RE: REVIEW OF SUNSET DEVELOPMENT SUBMITTAL

Subject: Sunset – Preliminary Plat

Subject: Sunset Preliminary Plat Submittal and Technical Review

**SUNSET
PRELIMINARY PLAT
SITE PLAN/PHASING PLAN**

Sheet
SP5
of
16
Date
APRIL 26, 2018

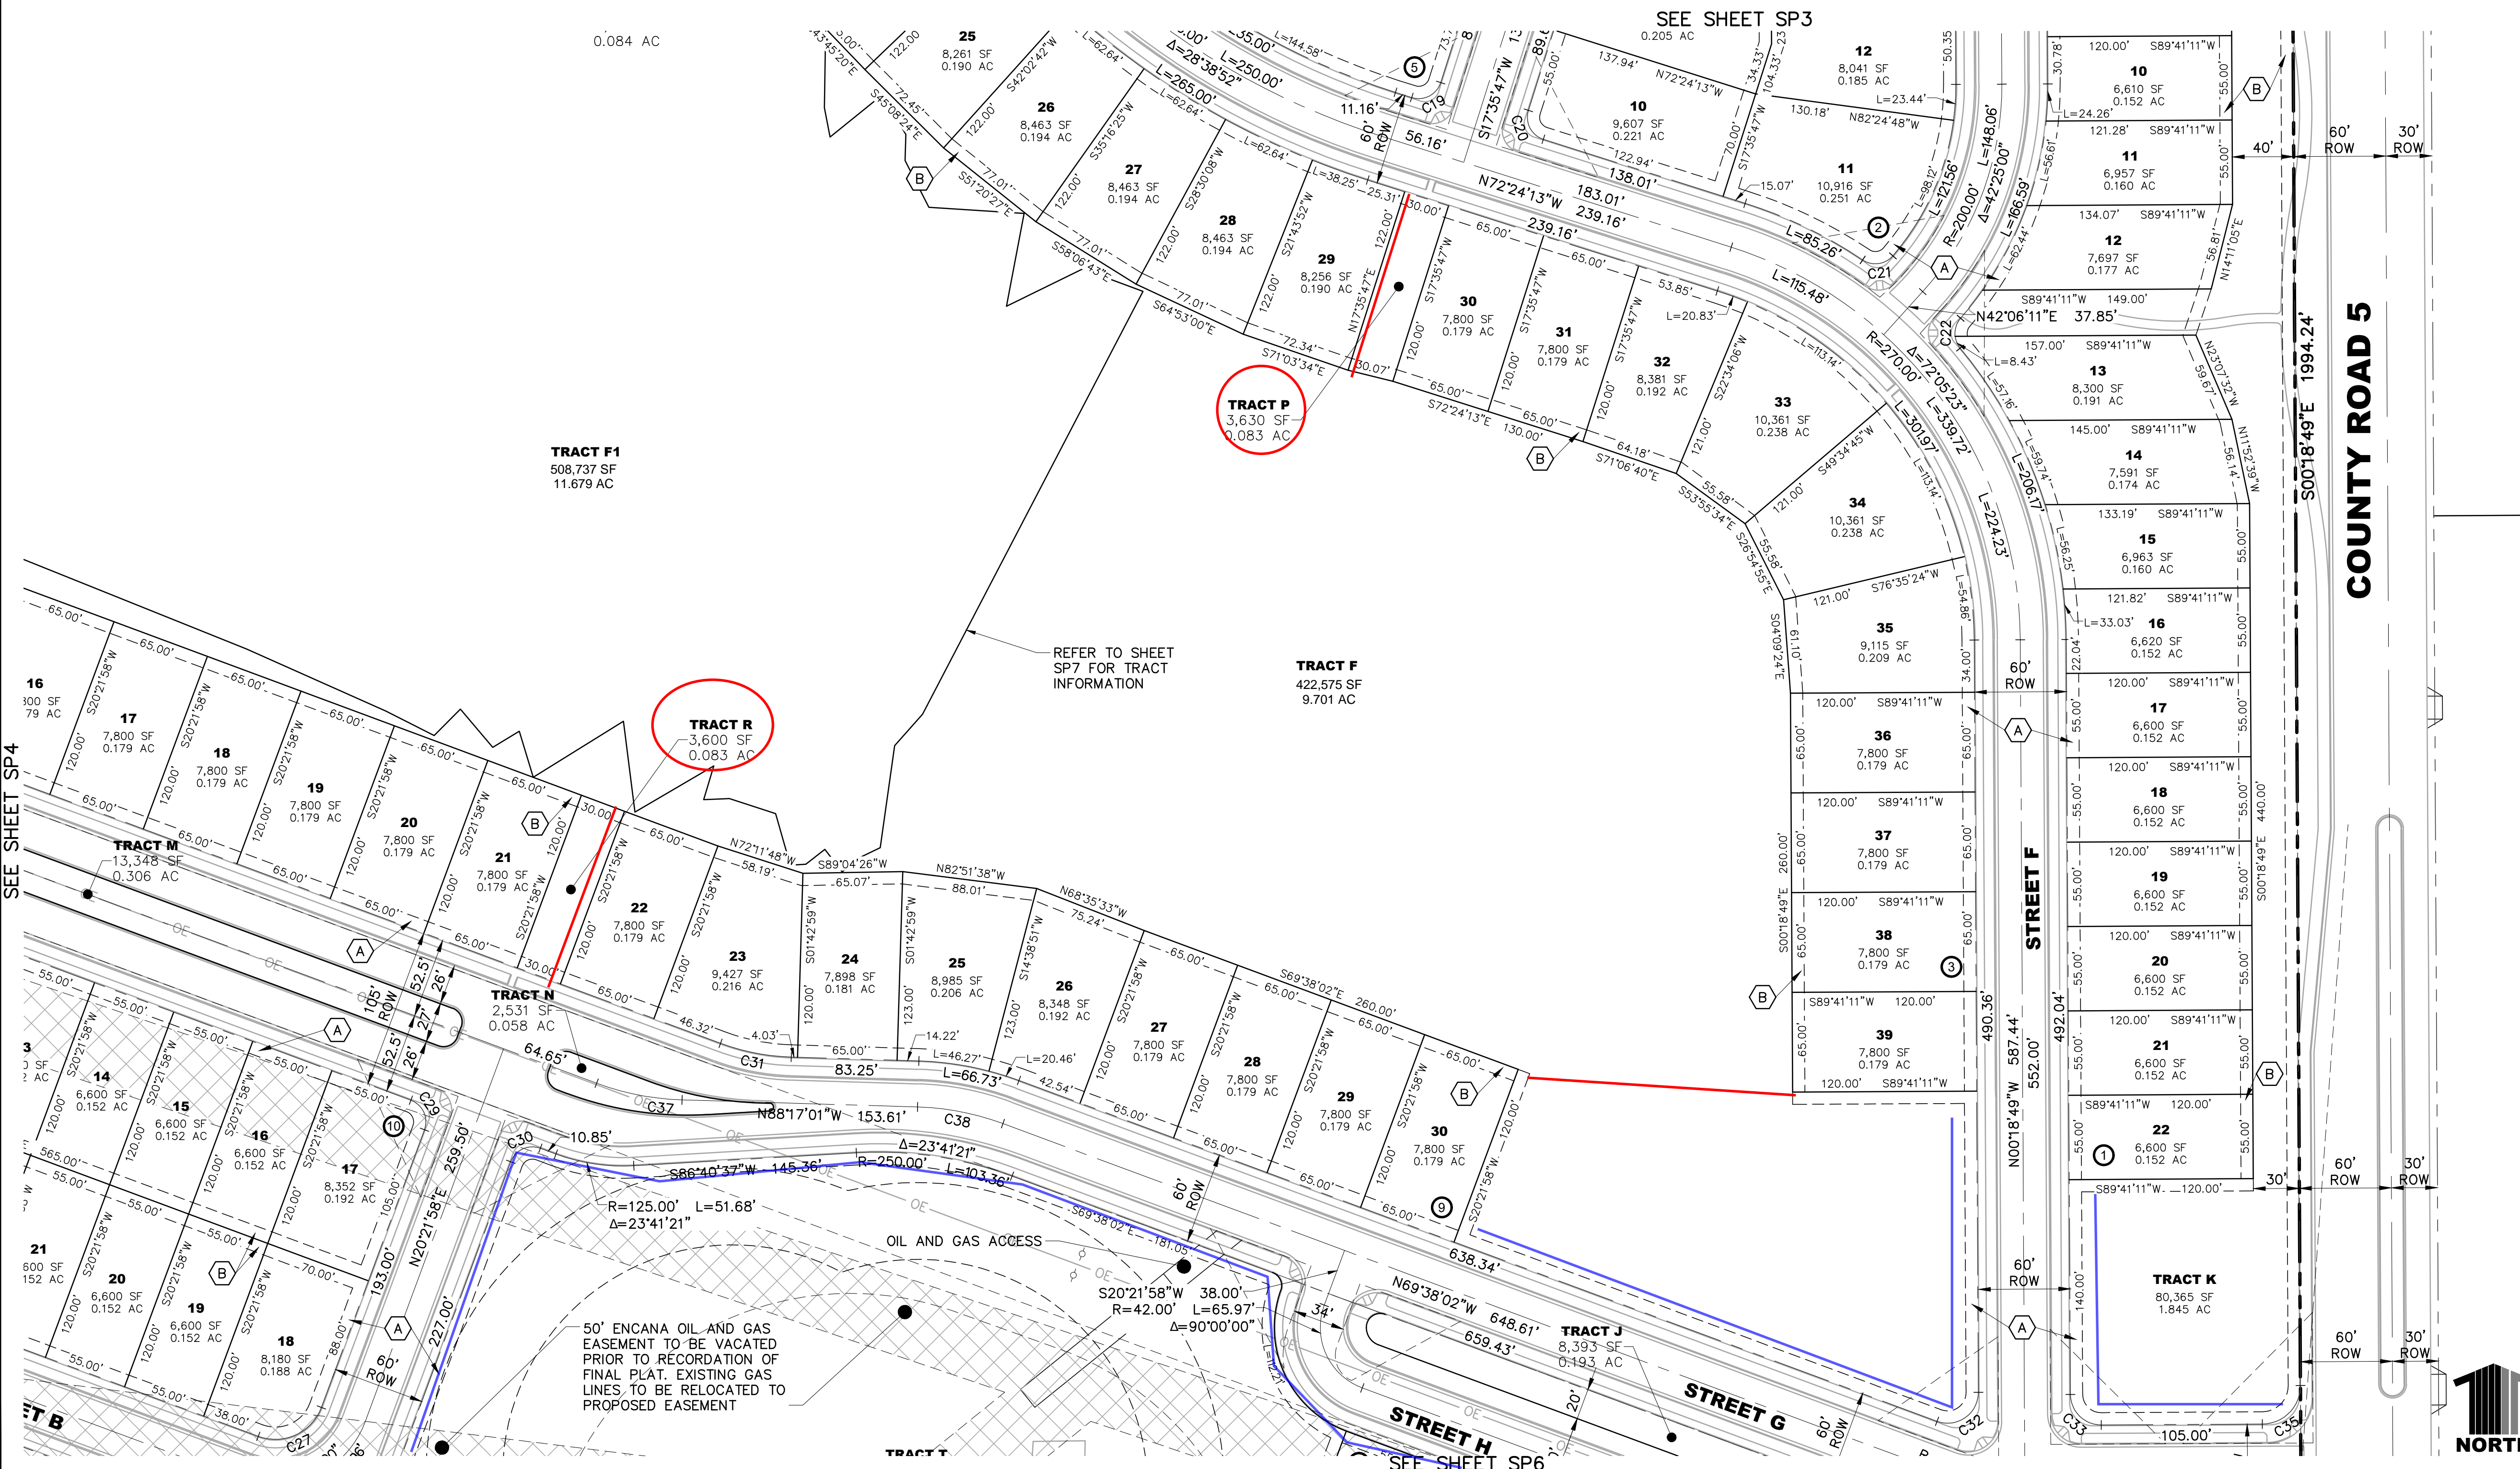
7. Sheet SP5 – Site Plan
 - a. The 30 foot wide tract located between Lots 30 and 31 should not be part of Tract F, this should be a separate tract owned and maintained by the HOA.
